West Midlands
Interchange

THE WEST MIDLANDS RAIL FREIGHT INTERCHANGE ORDER 201X

APPLICANT'S RESPONSES TO EXAMINING AUTHORITY FIRST WRITTEN QUESTIONS (ExQ1) - DOCUMENT 10.1

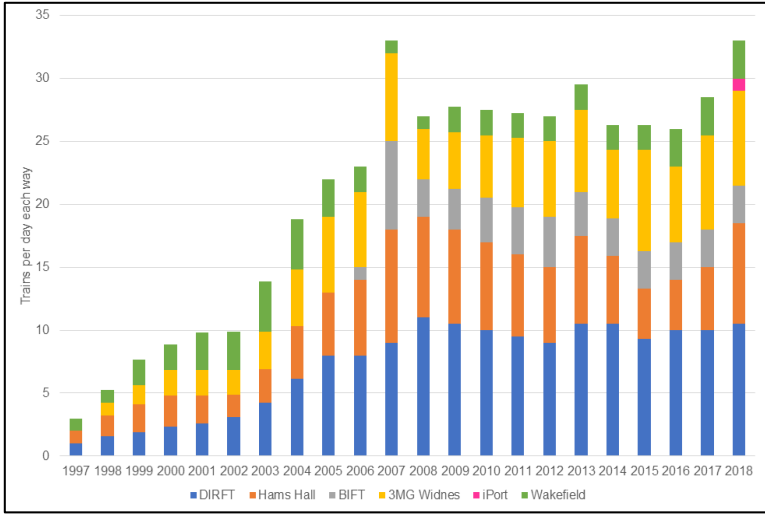
1.2.23.	The Applicant	The Rail Operations Report [APP-256] indicates that movement of containers from the Rail Terminal to and from the rail served warehouses may be undertaken by "tugmaster" vehicles.

ExQ1	Question to:	Question:	Applicant's Response
		<p>If this is considered to be a realistic prospect the Applicant is requested to produce a written note providing information on the following matters:</p> <p>(i) the extent to which these vehicles are currently used at existing SRFIs;</p>	<p>(i) Tugmasters and HGVs are used at DIRFT for moving containers between the rail terminals and warehouses operated by Tesco, Eddie Stobart and WH Malcolm. The picture below shows a Tesco tugmaster alongside an Eddie Stobart HGV.</p>  <p>Tugmasters are proposed to be introduced to the iPort SRFI in the next months as the rail terminal activities expand.</p> <p>Tugmasters are "Works Truck" and are an "excepted vehicle" according to para 11 of Schedule 1 to the</p>

ExQ1	Question to:	Question:	Applicant's Response
		<p>(ii) the extent to which the layout and form of those SRFIs where they are used is similarly to that proposed at WMI (including the nature and extent of any public highway used to undertake the transfer of containers from the rail terminal to warehouse units and vice versa); and</p> <p>(iii) what restrictions would apply to the use of such vehicles on the public highway having regard to matters such as road fund licence and insurance, weight limits and type of fuel used.</p>	<p>Hydrocarbon Oil Duties Act 1979. HMRC Excise Notice 75 gives examples of Works Trucks as being fork lift trucks, 'shunt' vehicles designed to haul articulated trailers and their goods around sites and in the context of SRFIs, special vehicles which lift and move freight containers around sites.</p> <p>(ii) Tugmasters are used within the DIRFT estate operating across and along private and public highways, and therefore operate in the same way as proposed for WMI. The journey from the rail terminal to the furthest potential warehouse customer at DIRFT I & II covers approximately 2.086km on adopted roads.</p> <p>The distance to the Tesco, Eddie Stobart and WH Malcolm warehouses at DIRFT is a maximum of approximately 1.136km, of which approximately 385m is on private roads. The equivalent distance at WMI to the furthest warehouse is approximately 2.05 km, of which approximately 1km is on adopted roads.</p> <p>(iii) Tugmasters operate on the public highway at DIRFT with rebated fuel and without a road licence with the approval of HM Revenue & Customs (HMRC) and the Vehicle & Operator Services Agency (VOSA).</p> <p>HMRC Excise Notice 75 and the FTA Yearbook of Road Transport Law 2019 states that "Works Trucks" (i.e.</p>

ExQ1	Question to:	Question:	Applicant's Response
			<p>Tugmasters) using rebated fuel must only be used on public roads:</p> <ul style="list-style-type: none"> • for carrying goods between private premises and a vehicle on a road no more than one kilometre away • when passing from one part of private premises to another • when passing between private premises and other private premises where the different premises are within one kilometre of each other. <p>The maximum gross weights for goods vehicles is set out in the Road Vehicles (Construction and Use) Regulations 1986 as amended and amount to 44 tonnes. Vehicles are permitted to operate at weights above 44 tonnes, subject to the provision of suitable licences. Any Tugmasters operating at WMI would be subject to the restrictions set out above and would use both private and public roads along the same principles of those which take place at DIRFT.</p>
